**TECHNICAL REVIEW COMMENTS  
ON THE PROPOSED PLAN  
FOR SKINNER LANDFILL**

**Skinner Landfill PRP Group**

**September 21, 1992**

DUNN CORPORATION  
1333 Butterfield Road, Suite 540  
Downers Grove, Illinois 60515

FIGURE 1  
COMPARISON OF THE NUMBER OF POTENTIAL EXPOSURE PATHWAYS  
ASSOCIATED WITH EACH REMEDIAL ALTERNATIVE  
DURING IMPLEMENTATION

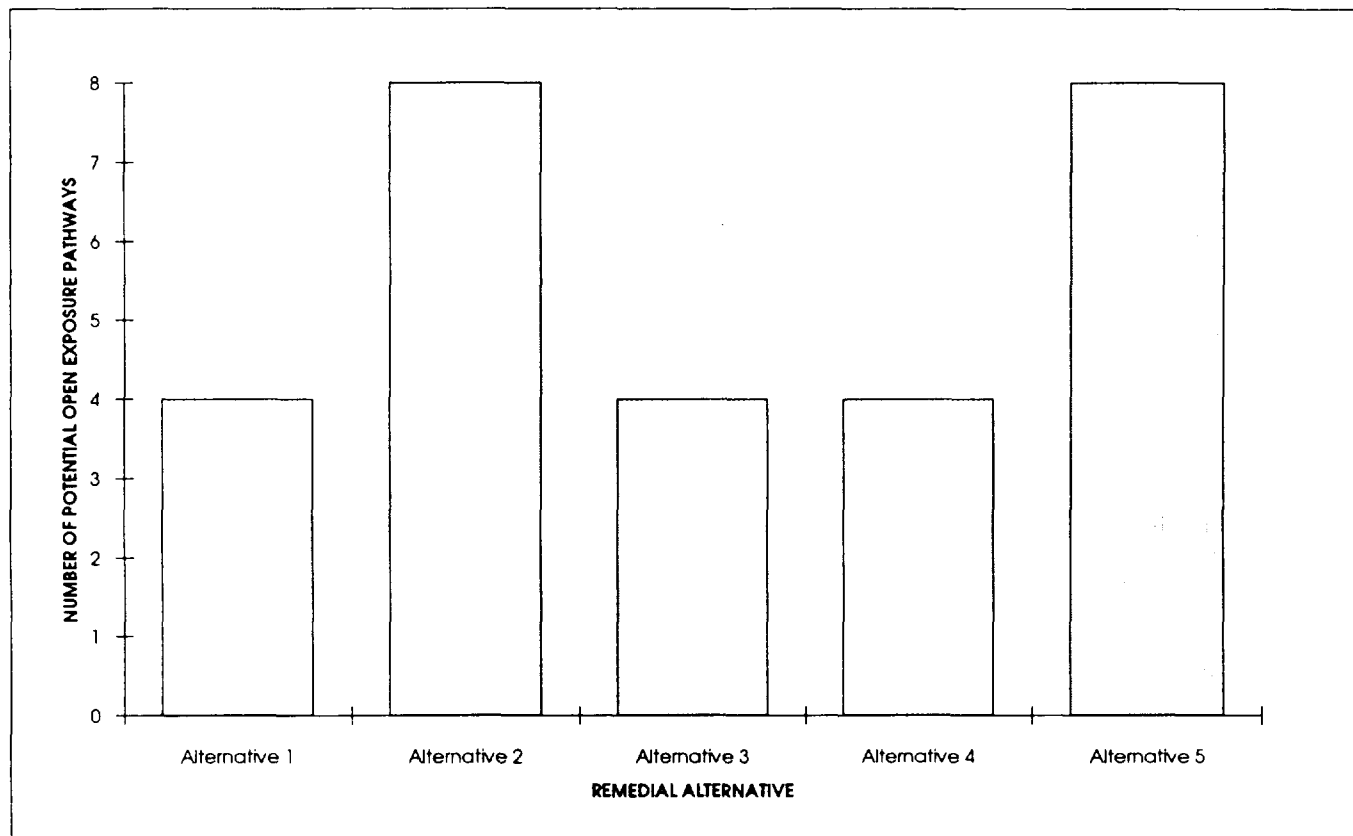
Figure 1 compares the number of exposure pathways associated with implementation of each remedial alternative. The figure shows that excavation and incineration alternatives create four additional pathways, doubling the number of potential exposure routes. Although the amount of risk posed by each pathway may vary, in general, the greater the number of pathways, the greater the risk of implementing the alternative.

COMPARISON OF THE NUMBER OF POTENTIAL RISK FACTORS  
ASSOCIATED WITH EACH REMEDIAL ALTERNATIVE

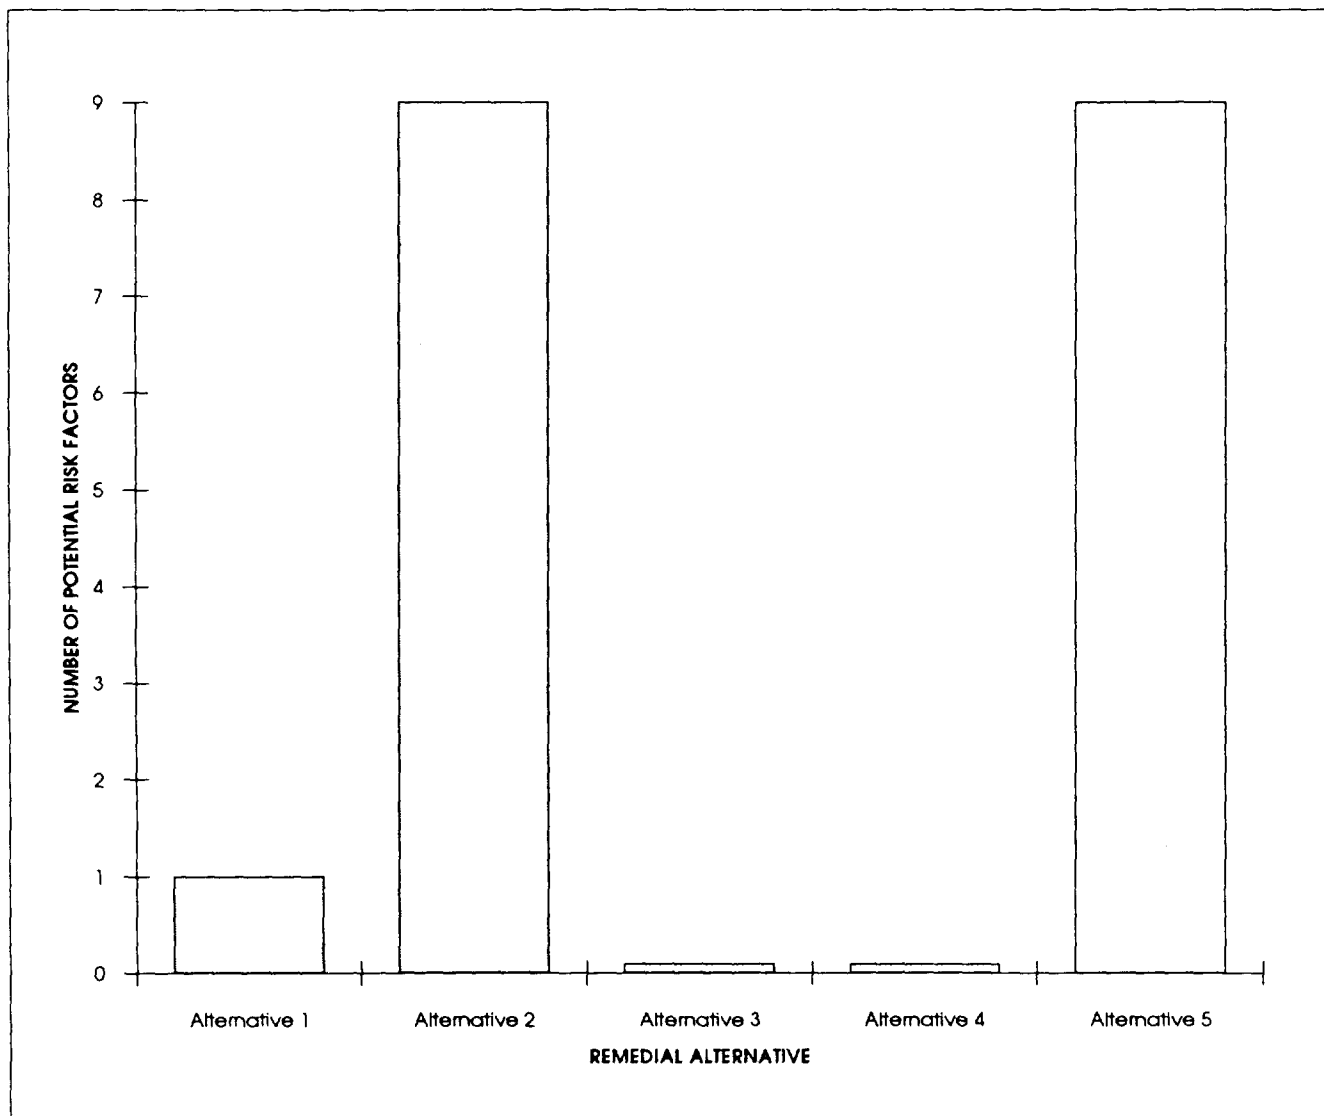
Figure 2 compares the number of potential risk factors associated with each alternative. It is clear that the capping alternatives provide significantly fewer potential risk factors to workers and the surrounding community. In fact, the no action alternative poses fewer potential risk factors than the incineration alternatives. The excavation of buried lagoon materials followed by on site incineration results in the greatest number of potential risk factors due to the diverse and heterogeneous nature of materials found on site.

COMPARISON OF THE POTENTIAL WEIGHTED RISK ASSOCIATED WITH  
EACH REMEDIAL ALTERNATIVE OVER THE REQUIRED IMPLEMENTATION TIMES

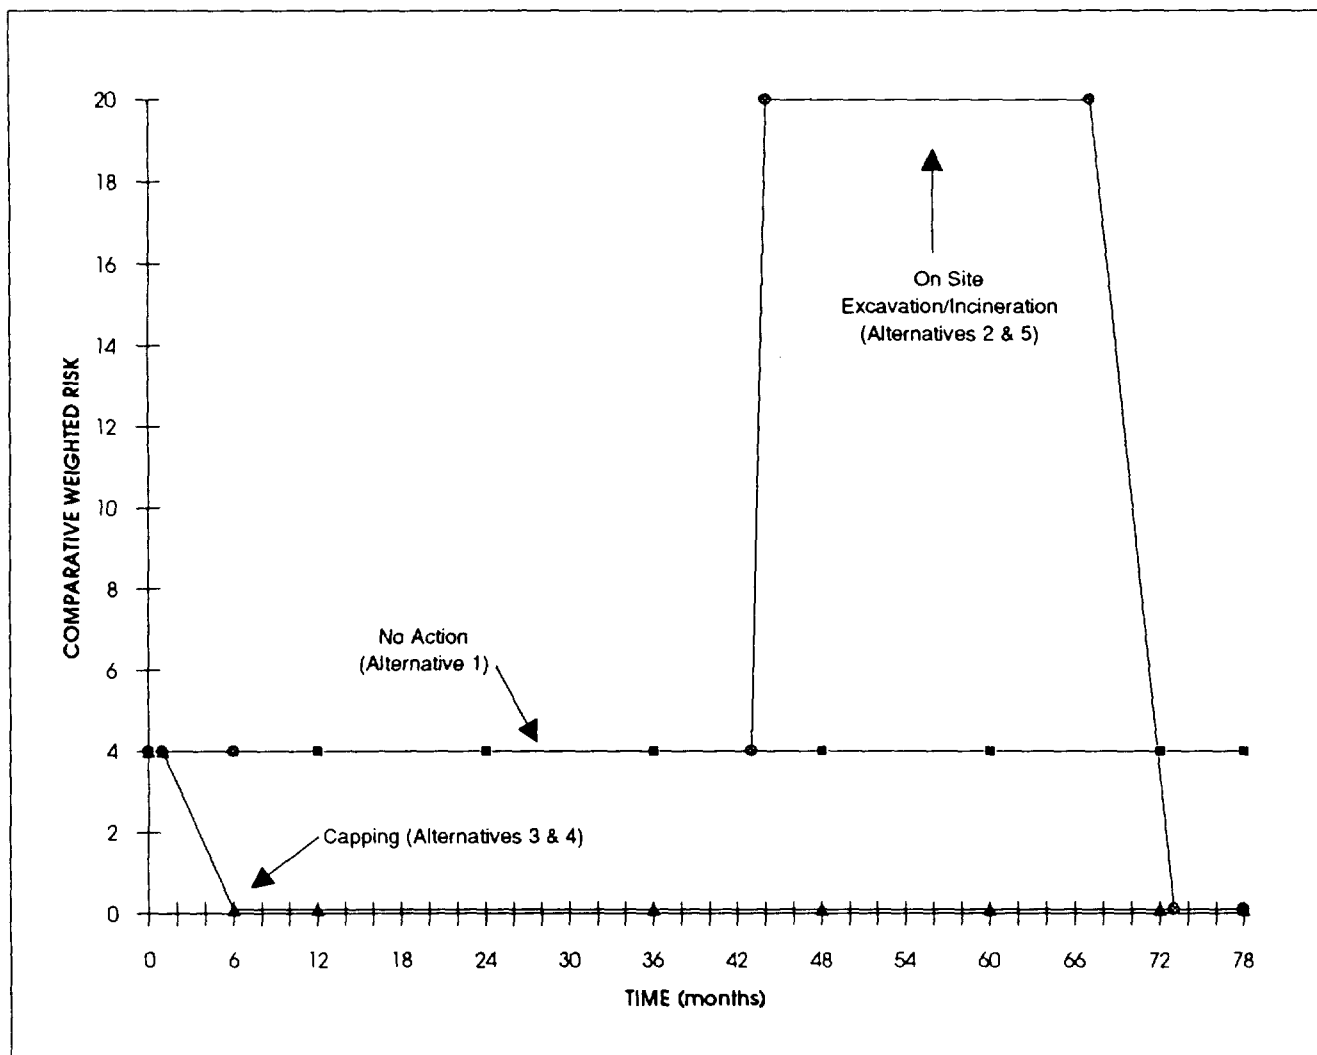
A qualitative comparison of the relative risk among USEPA's alternatives can be made by considering the number of chemical, physical, biological, and nuisance risk factors associated with each alternative and the time required to complete it (Figure 3). For the purposes of this comparison, each potential risk factor was weighted to reflect its relative risk. For the existing site conditions, the only associated risk factor is chemical toxicity. This factor was given a weight of 4, and the remaining risk factors were each assigned a weight based on their expected relative risk magnitude when compared with chemical toxicity. The total weighted risk for all of the risk factors is 20.

The capping alternatives remove the chemical toxicity risk factor over the estimated 6 months required for construction without involving any other risk factors. Unlike the capping alternatives, the excavation/incineration alternatives show no reduction of risk for 42 months during the time required for permitting, test burns, reviews, and system modifications. Once excavation and incineration begin, the number of potential risk factors increases. These elevated risk factors would remain constant until incineration is completed, a period estimated to be as much as an additional 24 months. As the incinerator was then decommissioned over a 6 month period, risk would be reduced to a low residual level. Thus, incineration would require at least 66 months more than capping to reach the same residual risk level.

COMPARISON OF THE TOTAL POTENTIAL EXPOSURE MONTHS \*\*  
ASSOCIATED WITH EACH REMEDIAL ALTERNATIVE  
DURING IMPLEMENTATION

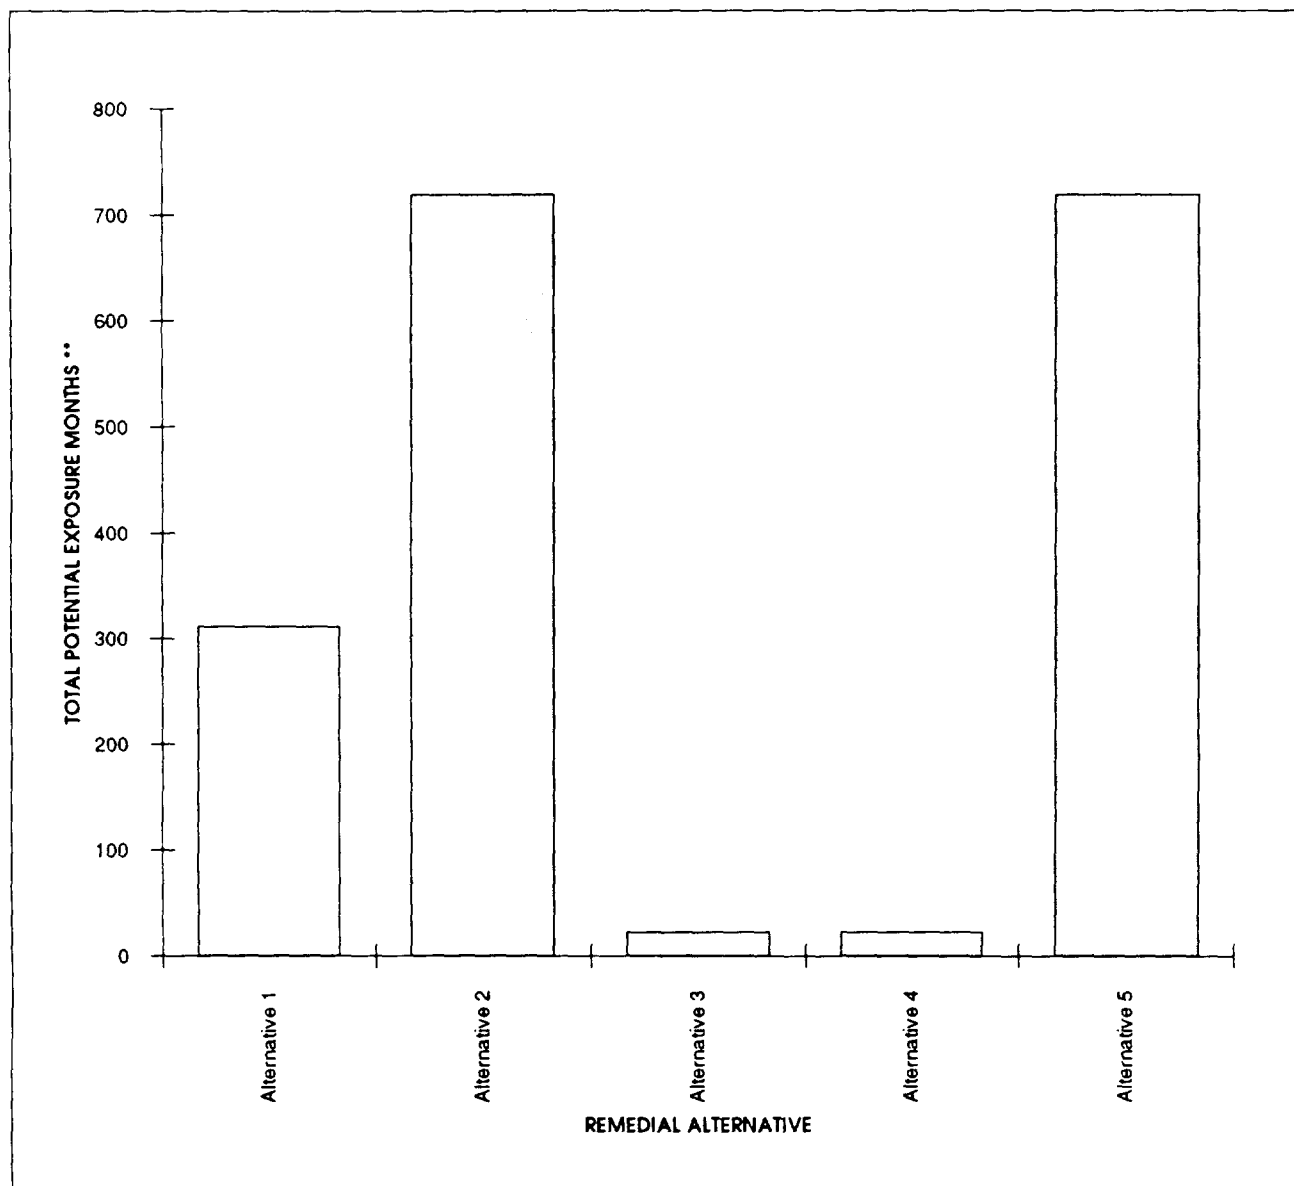
The results of this evaluation are presented in Figure 4, further illustrating that excavation and incineration alternatives present significantly greater total potential exposure than the capping alternatives. This is due to the creation of new exposure pathways, the resultant elevated number of weighted risks, and the increased time to implement incineration. This analysis did not consider the effects of potential operations delays, or the possibility of only operating the incinerator during school vacations, as suggested by USEPA during the July 29, 1992 public meeting. Thus, there may be intentional as well as unintentional extensions to the schedule of the incineration alternatives, causing the heightened risks of implementation to be prolonged.
